**Subject:** DEIR Public Comment to the Proposed Accretive Lilac Hills Ranch General Plan Amendment and Specific Plan PDS2012-3800-12-001(GPA), PDS2012-3810-12-001 (SP), DEIR Chapter 2 Analysis of **Cumulative Impacts** of the proposed Lilac Hills Ranch (LHR) Project

**Subject:** DEIR Public Comment to the Proposed Accretive Lilac Hills Ranch General Plan Amendment and Specific Plan PDS2012-3800-12-001(GPA),PDS2012-3810-12-001 (SP), Fire Protection Plan, Evacuation Study, and DEIR Chapter 2.7 Hazards

**Subject:** DEIR Public Comment to the Proposed Accretive Lilac Hills Ranch General Plan Amendment and Specific Plan PDS2012-3800-12-001(GPA), PDS2012-3810-12-001 (SP), DEIR Chapter 2.8 Noise; Noise Report of the proposed Lilac Hills Ranch (LHR) Project

**Subject:** DEIR Public Comment to the Proposed Accretive Lilac Hills Ranch General Plan Amendment and Specific Plan PDS2012-3800-12-001(GPA), PDS2012-3810-12-001 (SP), EIR Project Objectives

**Figure 1 – Westerly and Easterly Evacuation Routes**

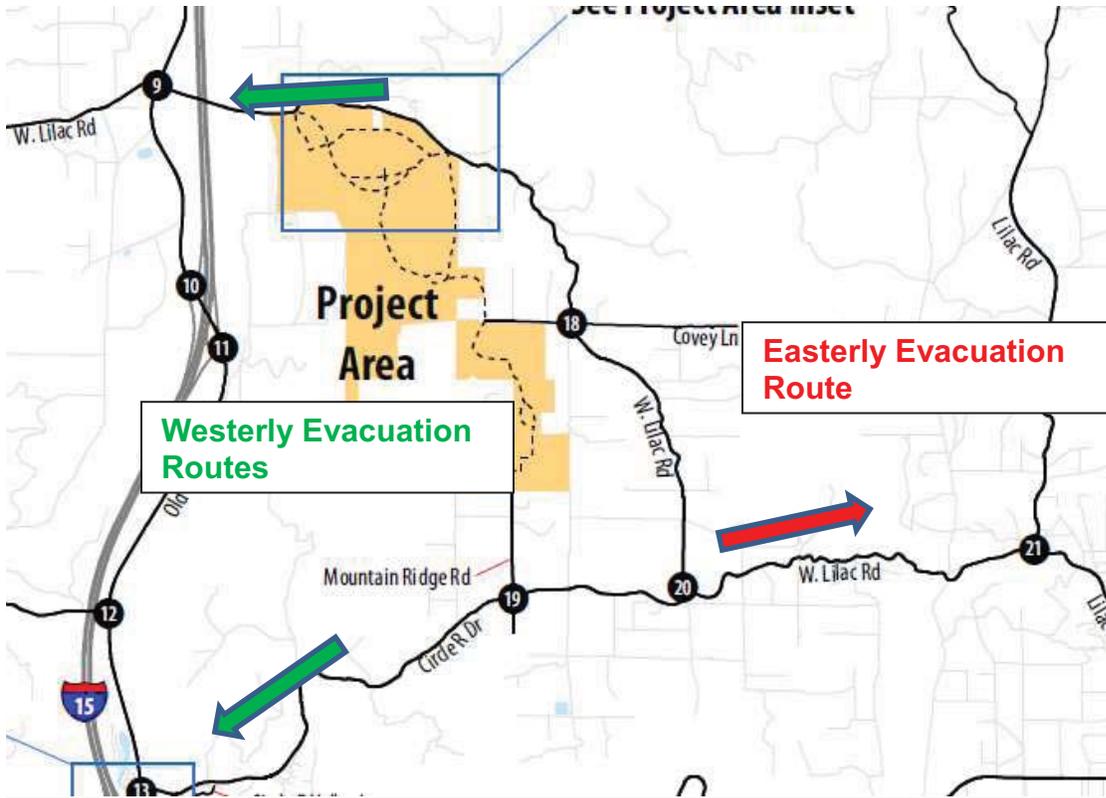
The Evacuation Plan does not address the most fundamental evacuation issue of the Proposed LHR Project – the limited number of roads for automobile evacuation of the 5185 residents of the proposed LHR Project when added to the cumulative impact of existing population that would be evacuating with trucks and trailers with livestock creates an unacceptable Safety Hazard.

The LHR Project has but two Public Roads that provide evacuation routes to the West: West Lilac Road to the north and Circle R Road to the South. Both are two lane rural Circulation Element 2.2 E roads for which **Accretive plans no upgrade**. Accretive is requesting exception to future County upgrade plans for portions of West Lilac Road to be **downgraded** from 2.2 C to 2.2 F capacity.

The LHR Project has but a single evacuation route to the East. That is the easterly section of West Lilac Road that connects to Lilac Road. It is a Circulation Element 2.2 E two lane rural road. The current “as built” configuration of this road does not meet current 2.2 E road design standards for certain design features, such as paved shoulder width, sight distance, design speed, curve radii, etc. In addition to the 5185 human in the LHR Project, this single evacuation route will also be used by the existing population for evacuation, leading to extreme Safety risks to human life.

Wildland Fires and Evacuation is a LHR Project **Significant** Environmental that the County has not mitigated.

**Figure 1 – Westerly and Easterly Evacuation Routes**

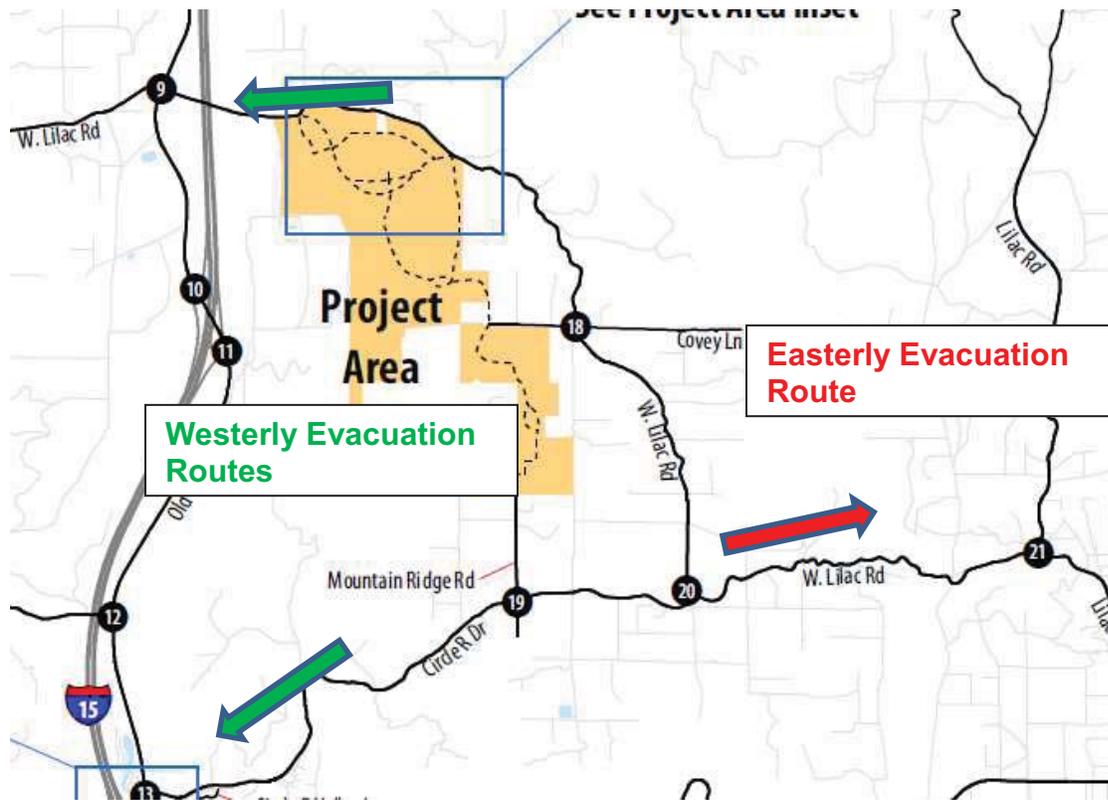
Evacuation Plan - The Evacuation Plan does not address the most fundamental evacuation issue of the Proposed LHR Project – the limited number of roads for automobile evacuation of the 5185 residents of the proposed LHR Project added to the existing area rural and semi-rural population.

The LHR Project has but two Public Roads that provide evacuation routes to the West: West Lilac Road to the north and Circle R Road to the South. Both are two lane rural Circulation Element 2.2 E roads for which **Accretive plans no upgrade**. Accretive is brazenly requesting exception to future County upgrade plans for portions of West Lilac Road to be **downgraded** from 2.2 C to 2.2 E capacity.

The LHR Project has but a single evacuation route to the East. That is the easterly section of West Lilac Road that connects to Lilac Road. It is a Circulation Element 2.2 E two lane rural road. The current as built configuration of this road does not meet current 2.2 E road design standards for certain design features, such as paved shoulder width, sight distance, design speed, curve radii, etc. There are no plans to upgrade this road. Accretive does not propose to pay for their direct development impact to this stretch of West Lilac Road.

What would happen if a Wildfire from the East driven by Santa Ana winds with the resulting large smoke plume required sudden Westerly evacuation of the LHR project?

**ATTACHMENT 1**  
**LILAC HILLS RANCH: REDUCE DESIGN SPEED**  
**MODIFICATION TO ROAD STANDARDS**

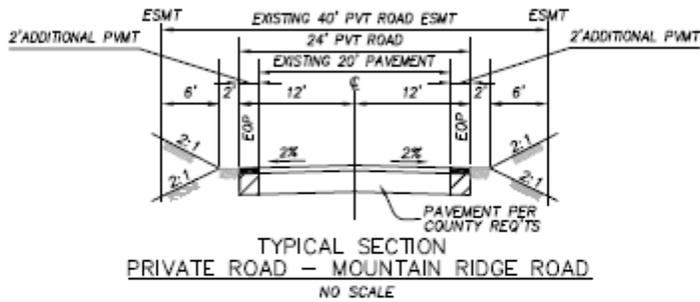
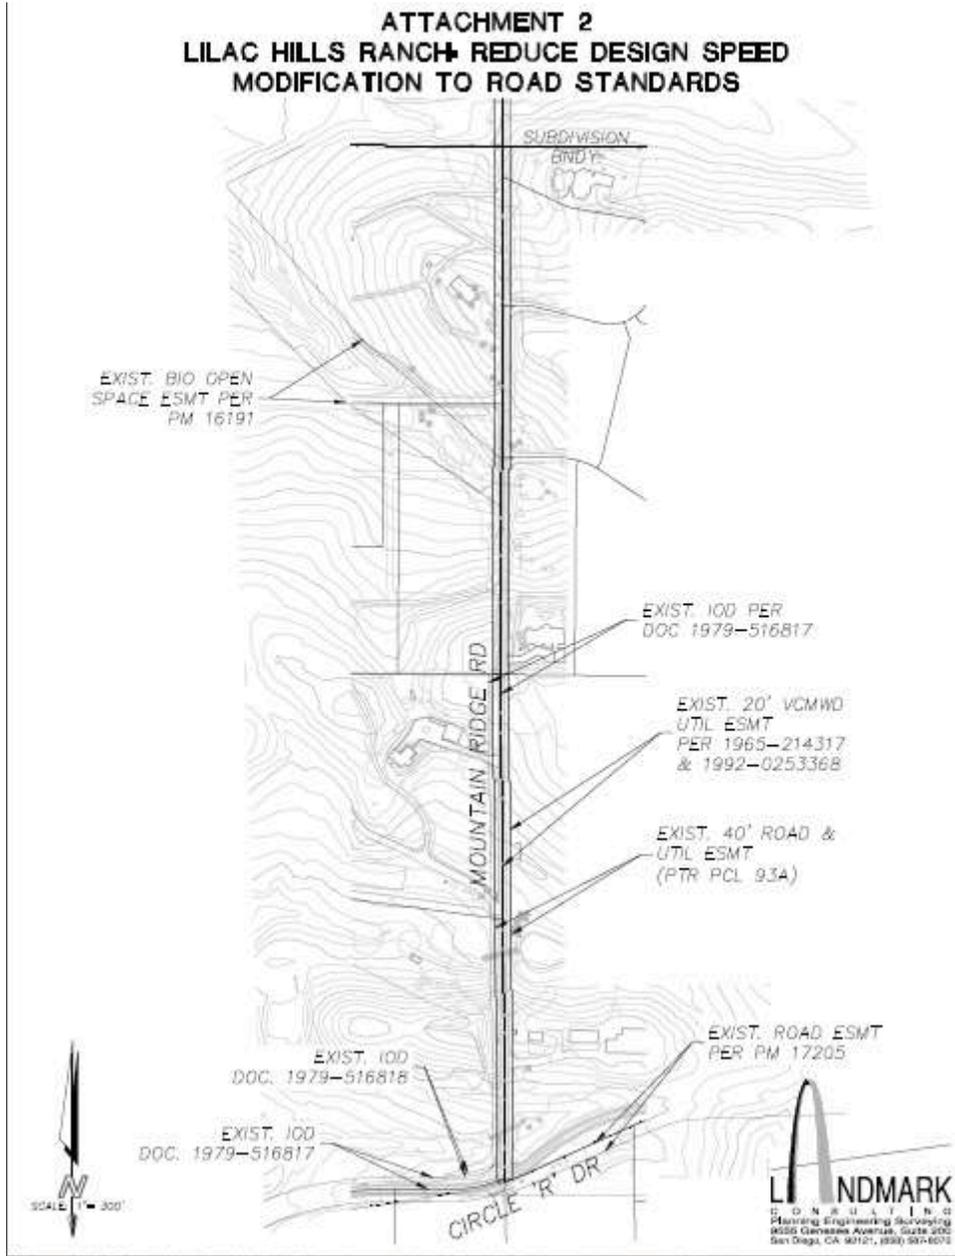
**Mountain Ridge Private Road** – The existing Mountain Ridge private road has a 16.6% Vertical Curve that the Applicant verifies on Sheet 8 of the LHR Master Tentative Map. This exceeds current Private Road Standards as well as being non-compliant with the Consolidated Fire Code.

Mountain Ridge is 2580 feet from the subdivision boundary to Circle R Public Road. Accretive is planning no improvement for Mountain Ridge other than adding 4 feet of paved surface (2 feet on each side). The resulting road does not meet San Diego County Consolidated Fire Code requirements. **The proposed road is non-compliant in Vertical Curve Requirements design and construction and does not meet two San Diego County Private Road Standards parameters. Compliance with San Diego County Road Standards is a requisite condition for compliance with the San Diego County Consolidated Fire Code.**

The Private Road standard street section is 24' paved, 28' graded within a 40' easement (see Attachment 1). Based on the average daily traffic, the minimum design speed is 25 mph for Mountain Ridge Road. The requested modification to the road standard is to allow for a 15 mph design speed over this existing private road (that was previously built to 15 mph standards as conditioned on an adjacent subdivision).

The requested road modification pertains to Mountain Ridge Road (private) north of Circle X Drive (see Attachment 1). At a 15 mph design speed, the existing road would have to be completely rebuilt. Existing vertical curves would have to be lengthened considerably (which would result in some existing driveways no longer being accessible since they are at the sag or peak of the existing curves). These driveways would need to be redesigned and rebuilt, while still access is maintained. Lastly, the newly designed road would require permission to grade from multiple neighbors. The cost and time to acquire these approvals would be considerable (if they would even be given from adjacent hostile neighbors).

Describe the hardship(s) to the property owner(s) and/or neighbor(s) if the request is not approved (see note 3. on reverse): The impact to the existing homes on this road would be tremendous and the need for permission to grade letters from a large number of neighbors could cause serious delays (and/or kill this project). Also, the additional costs to reconstruct this entire road and add many large retaining walls would be prohibitive. Access to some of the existing driveways (on the sags or peaks) may not even be possible. Finally, the existing Bio Open Space Easement would be impacted if the 25mph design was constructed.

**ATTACHMENT 1**  
**LILAC HILLS RANCH TAPER FOR RIGHT TURN MOVEMENT**  
**MODIFICATION TO ROAD STANDARDS**

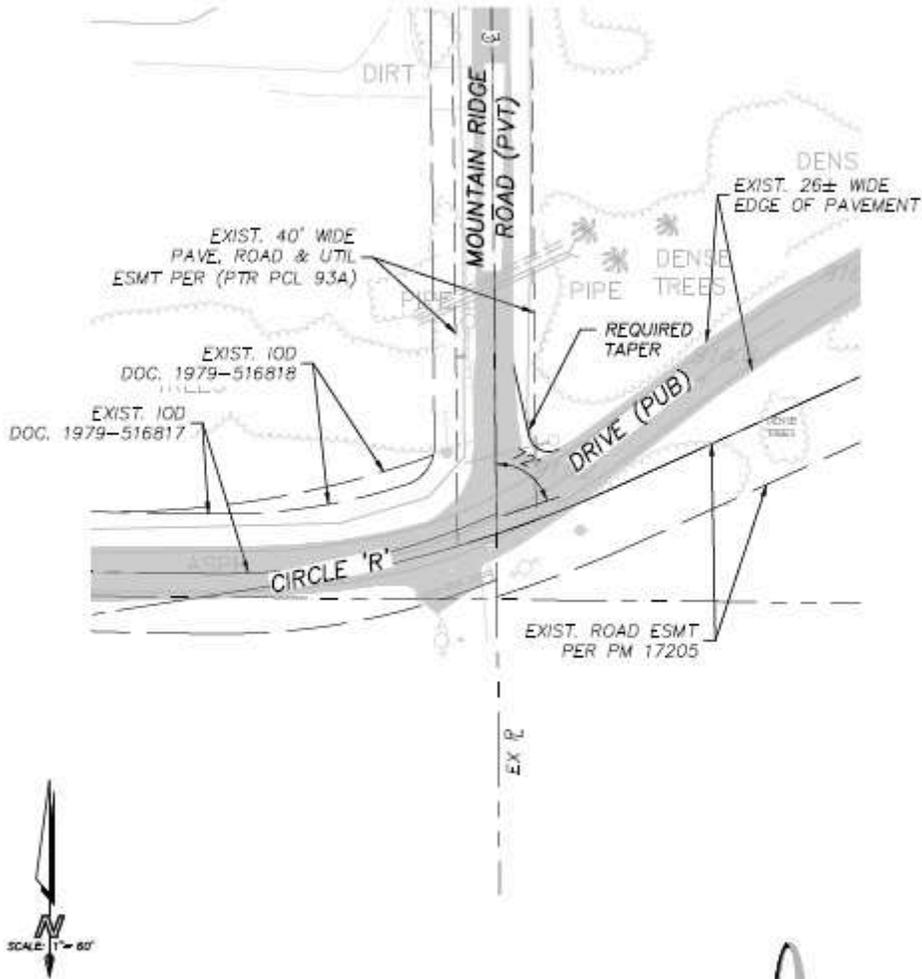
Requested Modification (attach engineering sketches showing existing layout, details and notes):  
The County Public road standard for the angle between centerlines at intersections is  
to be as nearly a right angle as possible and in no case less than 70 degrees or greater  
than 110 degrees. Angles between 70-80 (or 100-110)degrees will require a taper on the  
acute angle for right turn movement. The requested modification to the road standard  
is to waive this requirement for a taper.

Reason for requested Modification (provide attachment if additional space is required):  
This requested road modification is located at the intersection of Mountain Ridge Road  
and Circle R Drive, where the existing centerline of Mountain Ridge intersects Circle R  
at 72 degrees. This would require a taper for right turns from westbound Circle R Road  
onto Mountain Ridge Rd. Currently there is no right-of-way on this portion of Circle R  
Road and no room for a taper (see Attachment 1). This offsite property owner is hostile  
project and could hold up the entire project. Also, the traffic movement from westbound  
Circle 'R' Drive to northbound Mountain Ridge Road is very minimal.

List alternatives that could mitigate the requested Modification (attach engineering sketches showing proposed layouts, details and notes):  
Redesign Mtn Ridge Rd to approach Circle R at 90 degrees

**FIGURE 2**  
SIGHT DISTANCE ANALYSIS  
WEST LILAC ROAD AND COVEY LANE

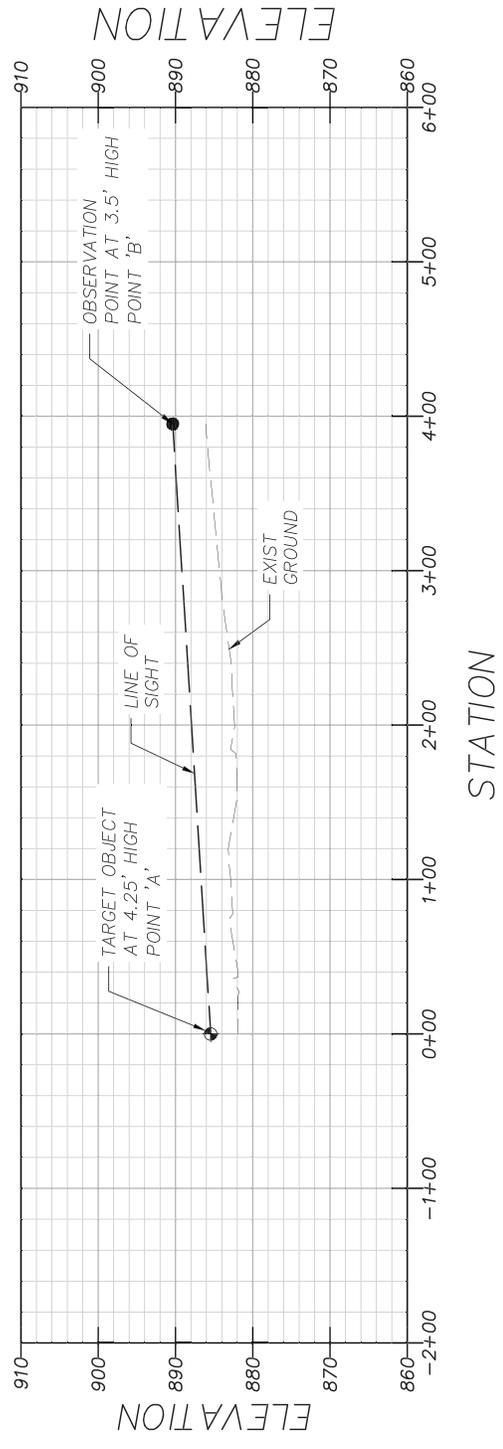
**Covey Lane** – The Applicant submitted the June 25, 2013 Sight Distance Analysis enclosed in Attachment F for the proposed intersection with West Lilac Lane. This intersection **fails to meet Sight Distance requirements.** Question – Please answer how the Applicant expects to gain the additional rights required to grade a substantial portion of a parcel of land that they do not own rights on to achieve Sight Distance standards compliance.

Currently, the maximum line of sight distance from Observation Point 'B' looking south toward Object Target 'C' on West Lilac Road is 330' assuming no clearing or grading is completed. A line of sight distance of 480' can be achieved by grading and clearing dense trees and brush in an area on property APN 129-190-44. In order to mitigate for the 480' Line of Sight distance requirement, a clear space easement with grading rights should be obtained (as illustrated in Figure 2).

FIGURE 27-1

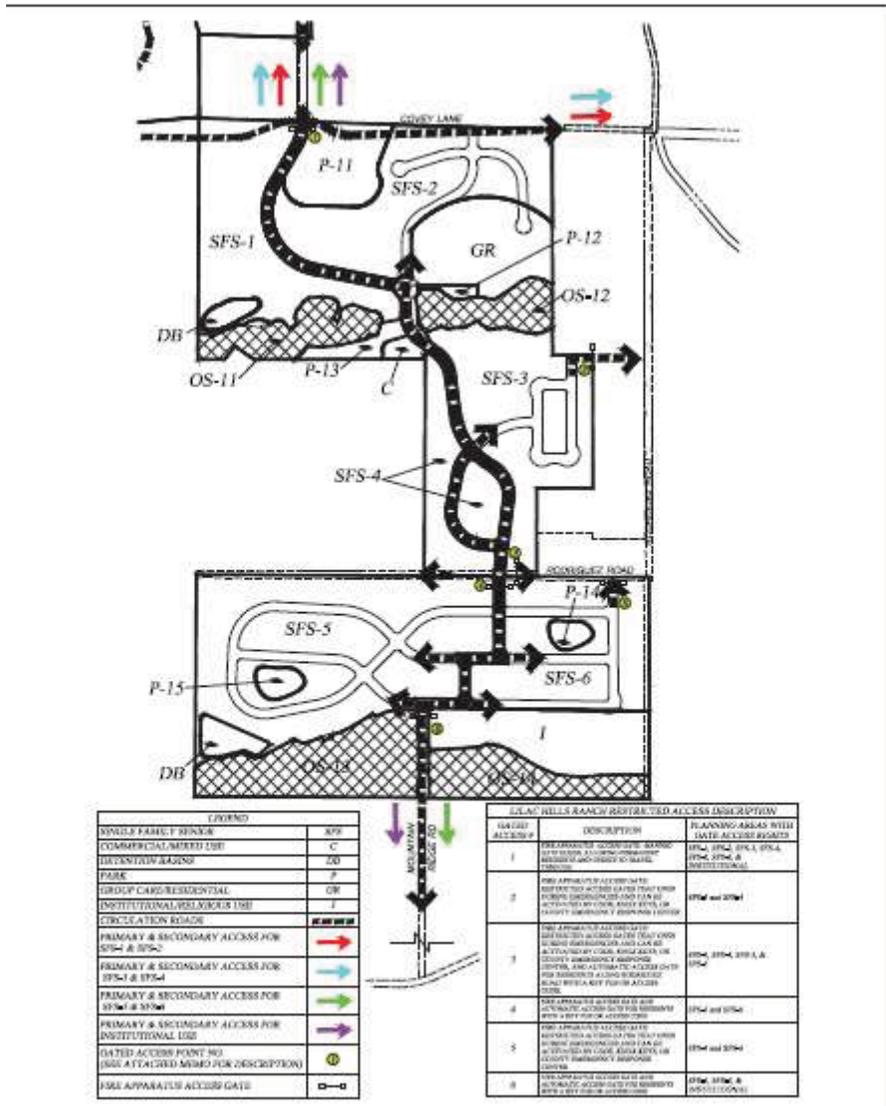
The inclusion of six electronic gates across fire access roads in Project design is problematic. Additional analysis needs to be performed in the FPP. Particularly troubling scenarios are potential routes that have more than one gate to access in series to provide emergency Fire and EMS services.

Why was the FIGURE 2.7-1 Project Gated Access graphic (Attachment G) not included and it’s Environmental Impacts with respect to human safety discussed in the FPP?

Please revise the FPP to include these vital analyses and resubmit with an additional 45 day Public Comment Period.

FIGURE 1-6  
Fire Protection Plan

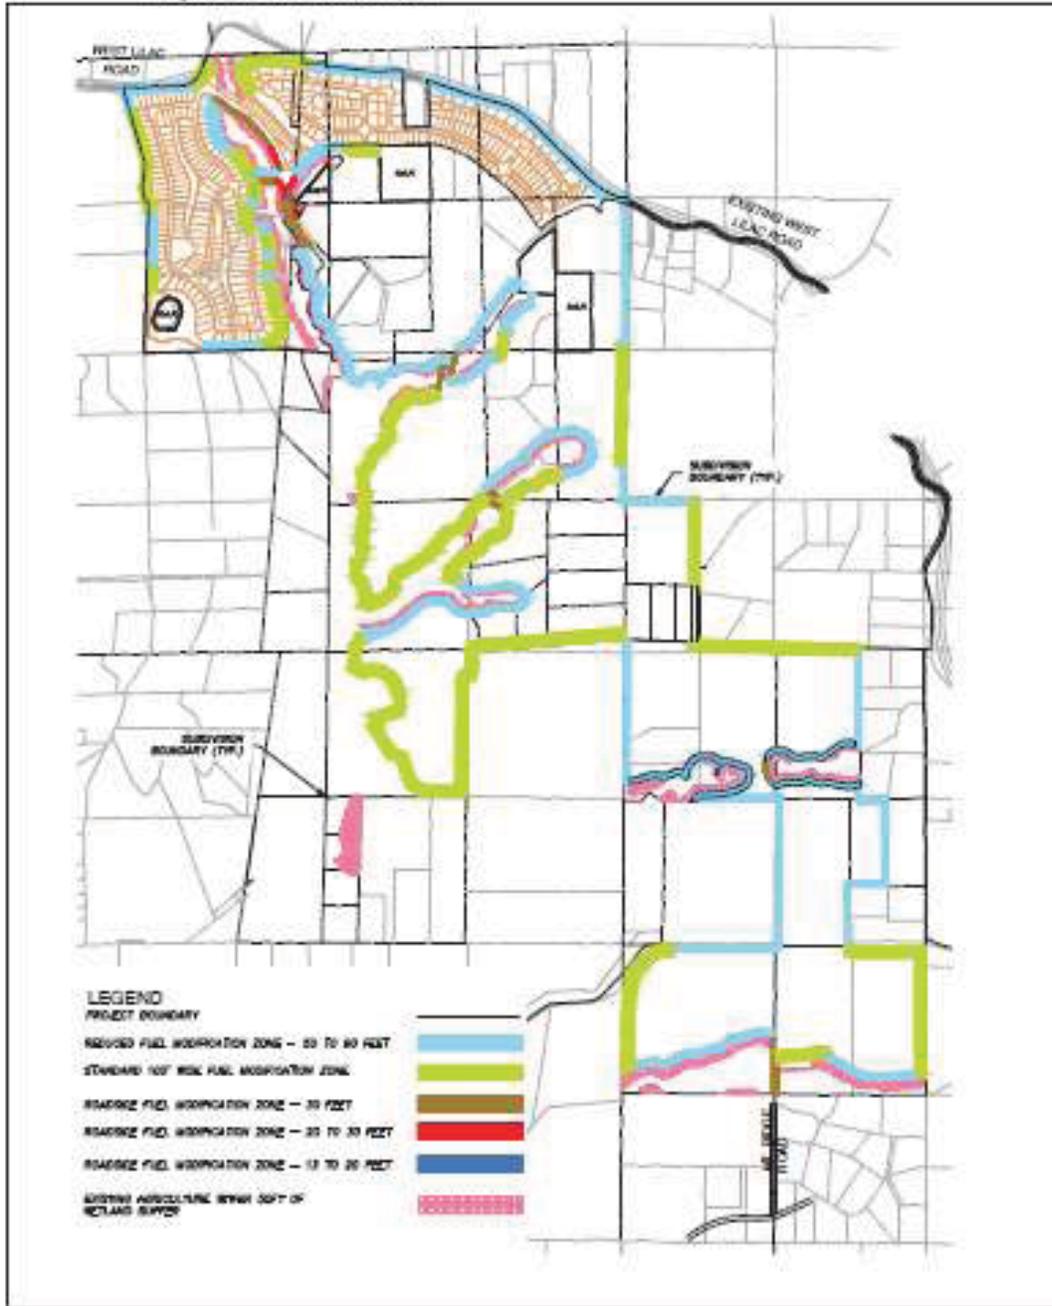
Issue 5 - Fuel Modification Zones (FMZ) – Section 5.4 Fuel Management Zones on page 42 of the FPP states “The project includes a few areas where fuel modification zones are less than 100 feet wide. Based on even a quick scan of Figure 1.6 from Chapter 1 of the DEIR (Attachment H) the more accurate and true statement is: **“The project includes extensive areas where fuel management zones are less than 100 feet wide.”**”

Why was Figure 1.6 not included, analyzed, and every exception to the 100 foot FMZ requirement discussed in the FPP and Chapter 2.7 Subchapter 2.7.3.4 Issue 4: Wildland Fires? Please revise both documents to assess these concerns and recycle for a 45 day Public Comment Period so that Environmental Impacts and mitigations can be assessed.
